Z-01 Base Price at Removed Music Wing
Allstate Construction, Inc.
10-17-2025

Z-02 Base Price at Removed Mini-Gym Wing
Allstate Construction, Inc.
10-17-2025

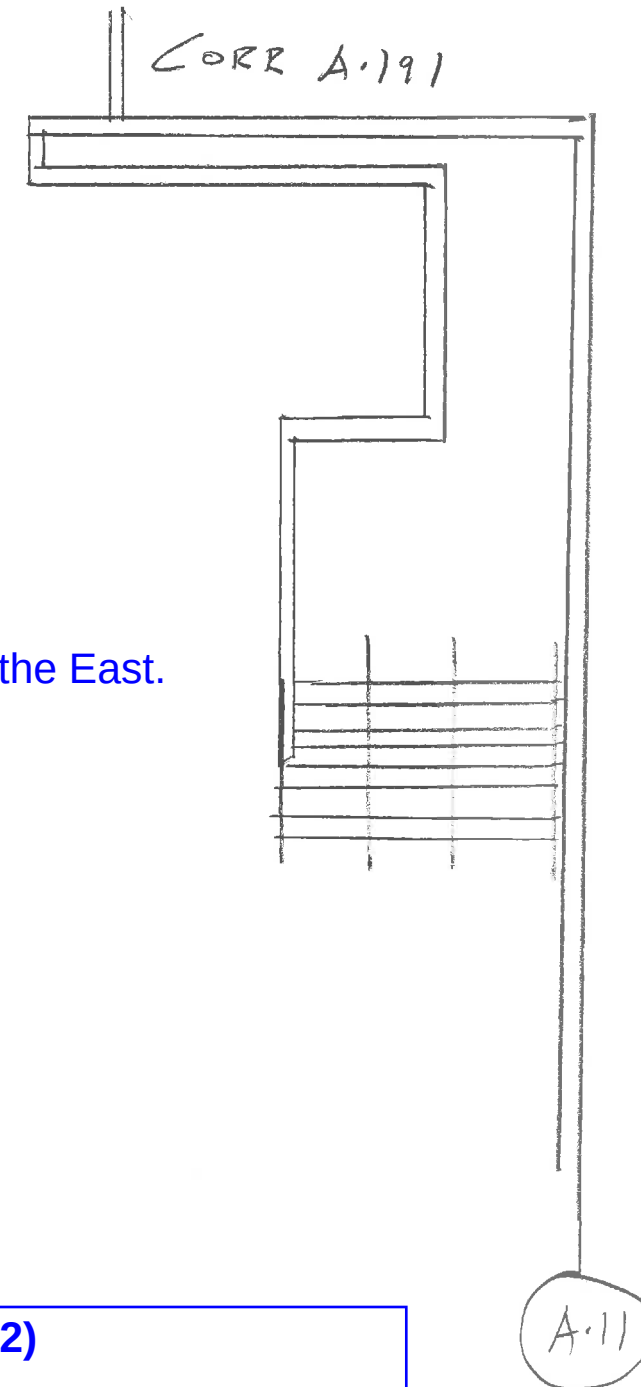
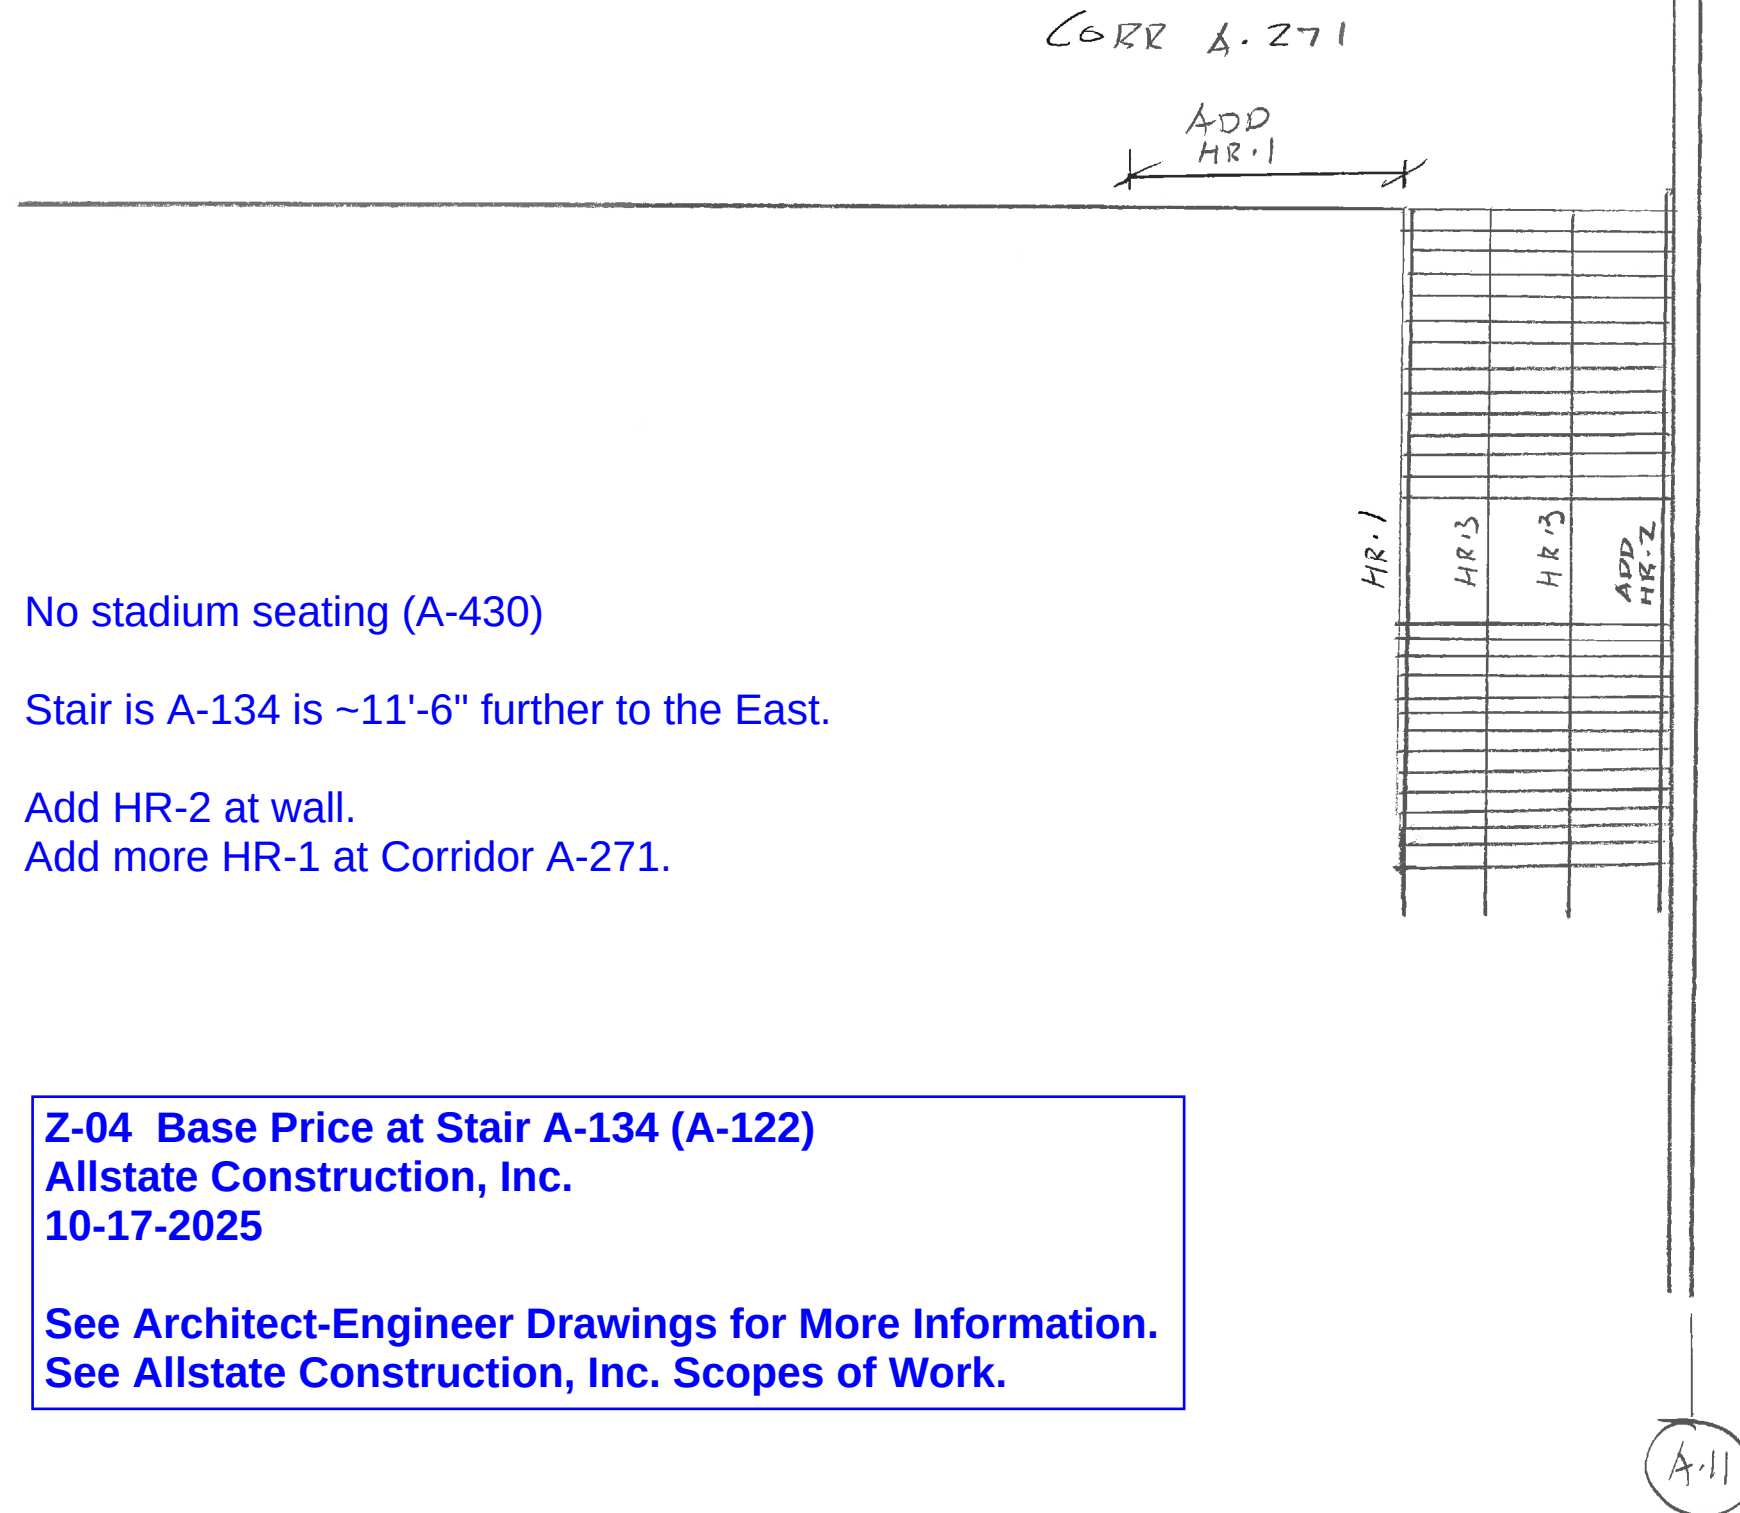
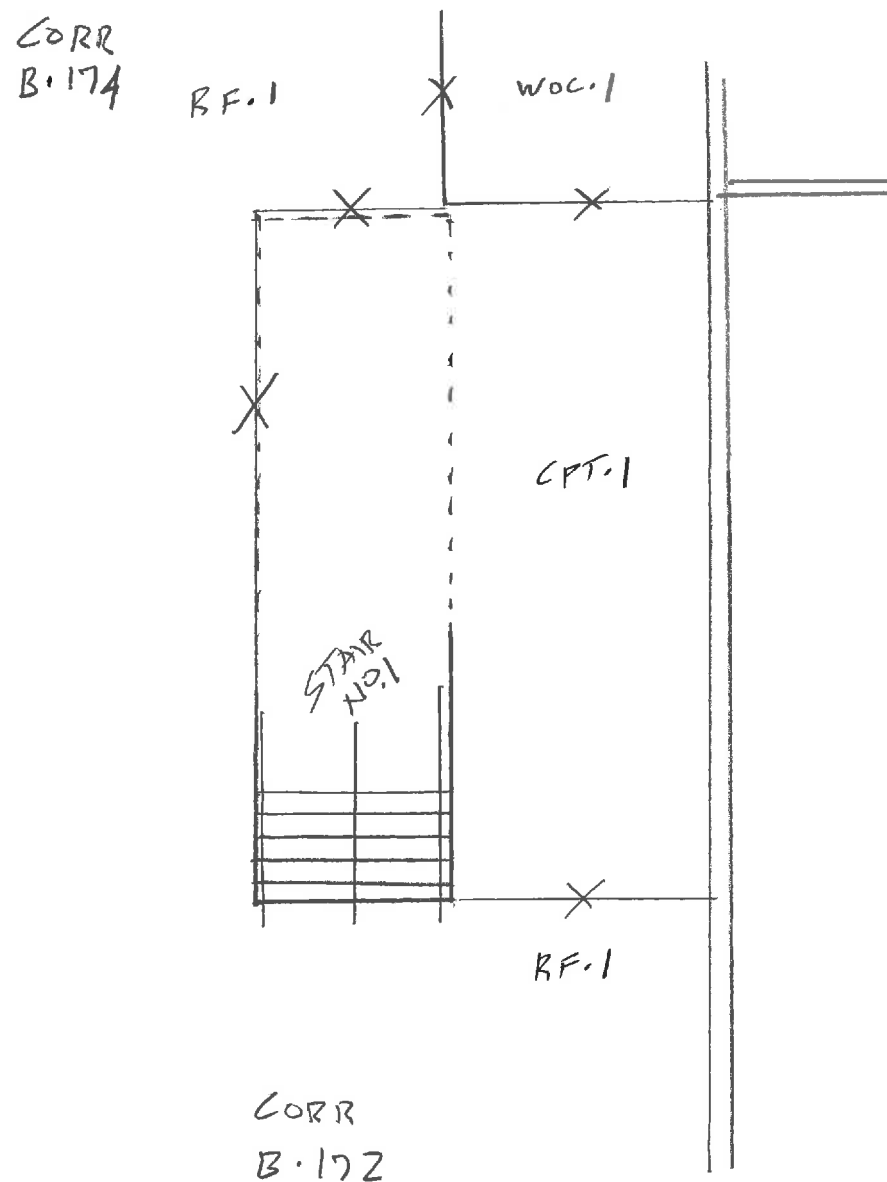
No stadium seating (A-430)

Stair is A-134 is ~11'-6" further to the East.

Add HR-2 at wall.

Add more flooring RF-1.

Z-03 Base Price at Stair A-134 (A-112)
Allstate Construction, Inc.
10-17-2025

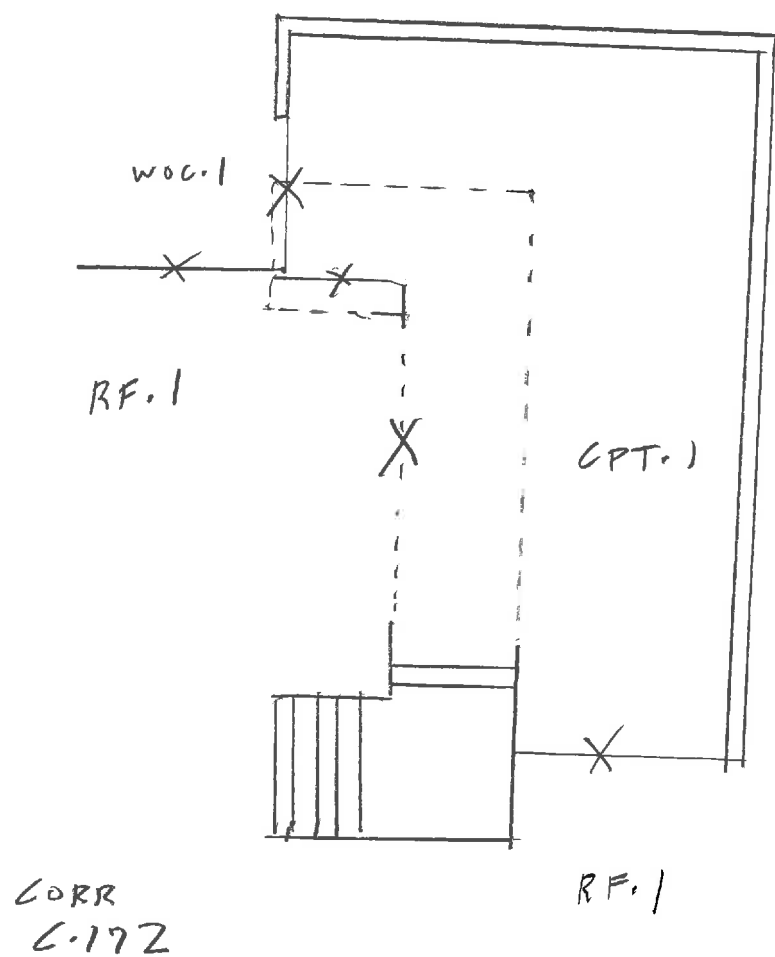
No under-stair seating (A-432.1)
No built-in seating (A-432.1)
No built-in screen walls (A-432.1)
No built-in floating desks (A-432.1)

Include cane detection rail "CDR" under stairs.
Include carpet under stairs with transitions.

Z-05 Base Price at Stair B-175 (A-114)
Allstate Construction, Inc.
10-17-2025

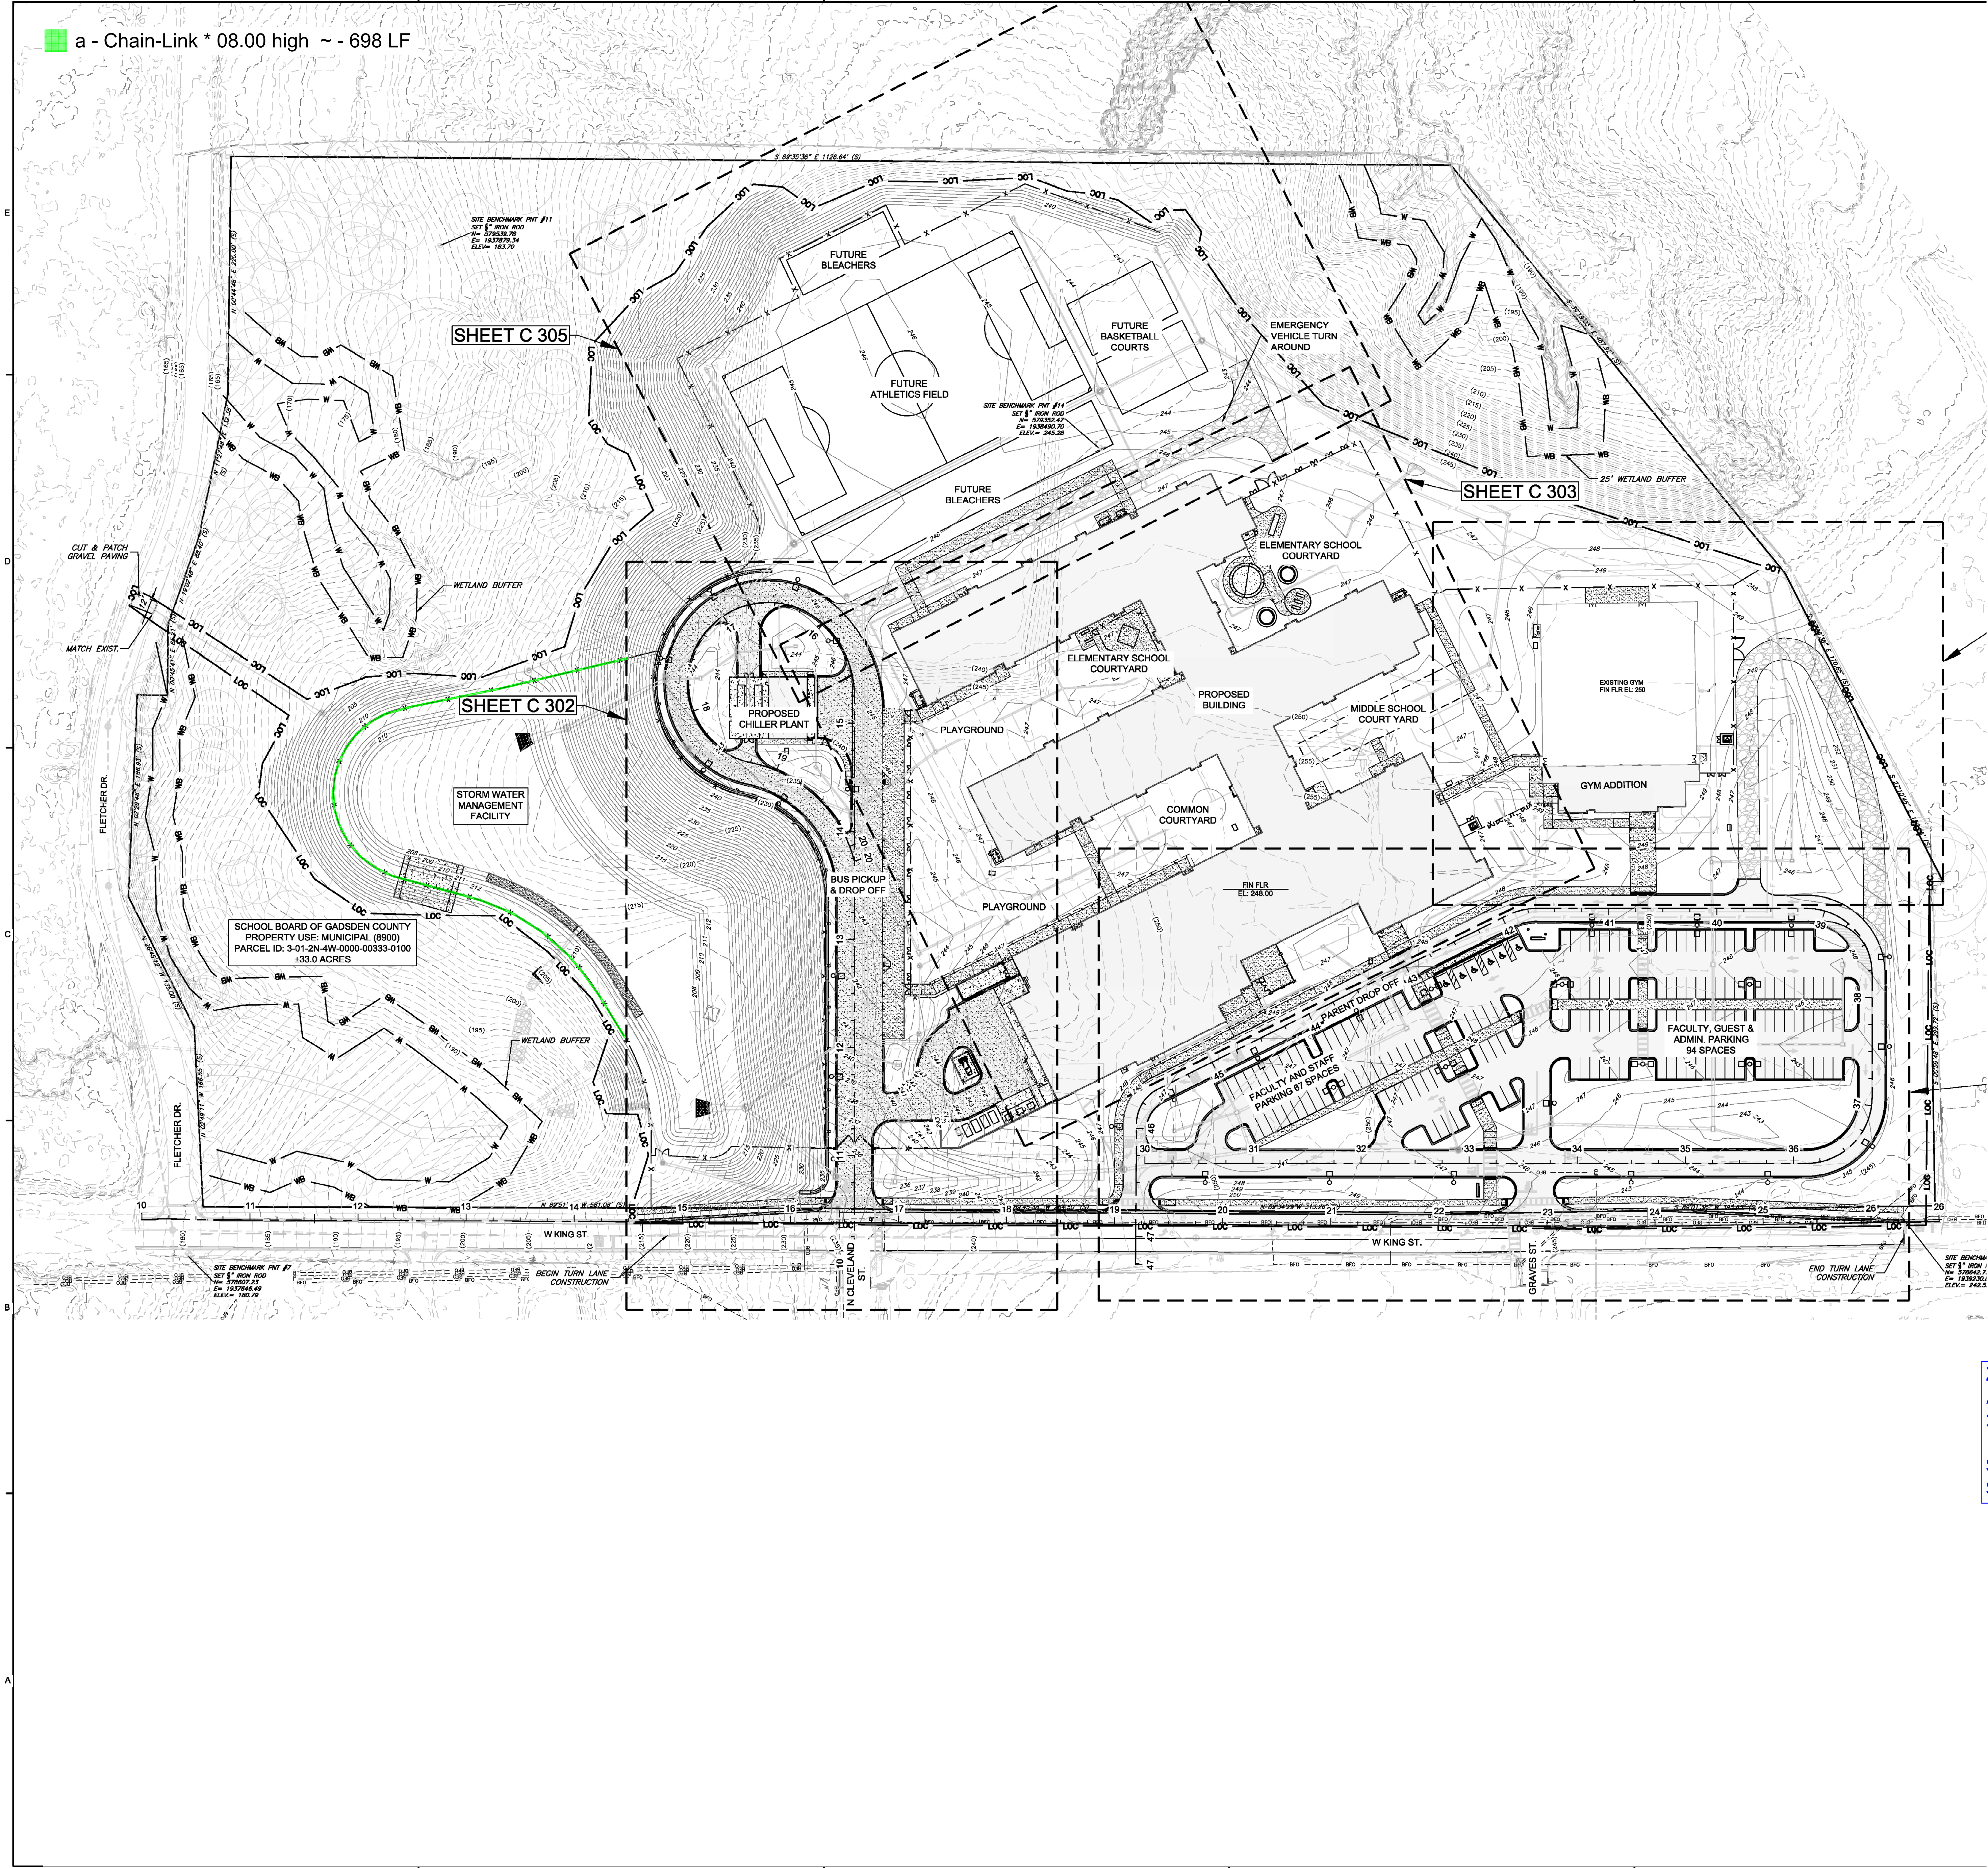
No under-stair seating (A-433.1)
 No built-in seating (A-433.1)
 No built-in screen walls (A-433.1)
 No built-in floating desks (A-433.1)

Include cane detection rail "CDR" under stairs.
 Include carpet under stairs with transitions.
